Service Advisory

CC-695

Models Affected: **S6031-KW** (53AI8DU6050).
S7237-KW (53AI8DU8050).
 Serial Number Range Affected: All 2009 Built Units.
 Date: **November 17, 2010**
 Subject: **TANK-S Steering Gear Kit 759-04280.**

FIGURE 1

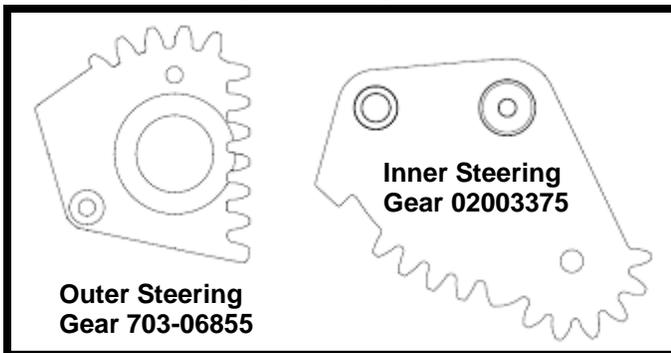
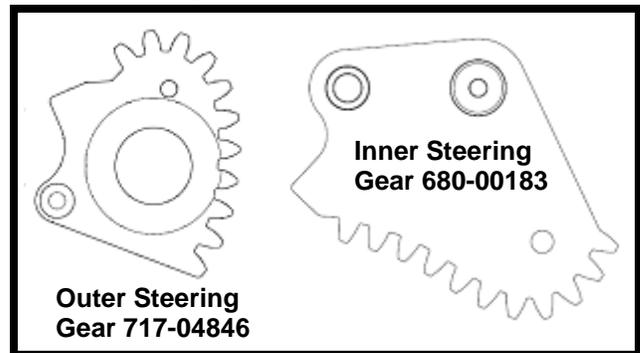
PURPOSE: The inner steering gear assembly **02003375** and the outer steering gear **703-06855** are **No Longer Available**. When replacing either gear it is **MANDATORY** to replace all gears both left and right, inner and outer as a set. **NOTE: Never mix old style steering gears with new style steering gears. See Figure 1 & Figure 2 below for identifying parts.**

Old Style No Longer Available

New Style Included In 759-04280

FIGURE 2

FIGURE 3

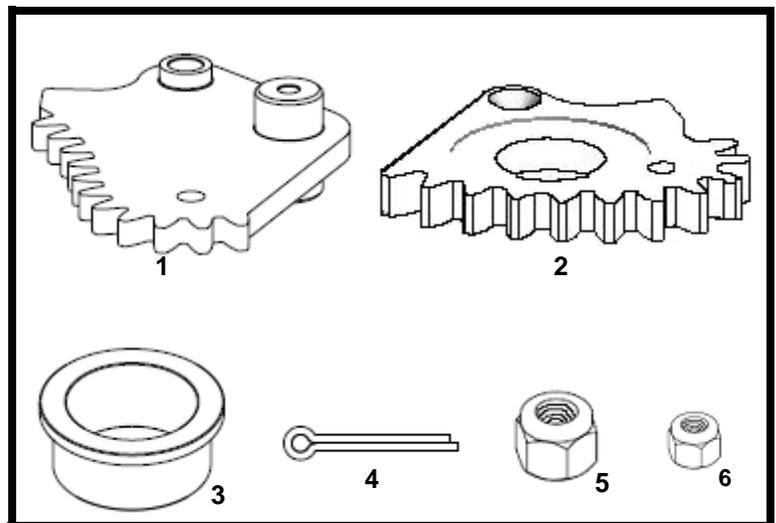
Service Kit **759-04280** consist of both left and right, inner and outer new style steering gears, new flange bushings for the inner steering gears and mounting hardware See Figure 3.
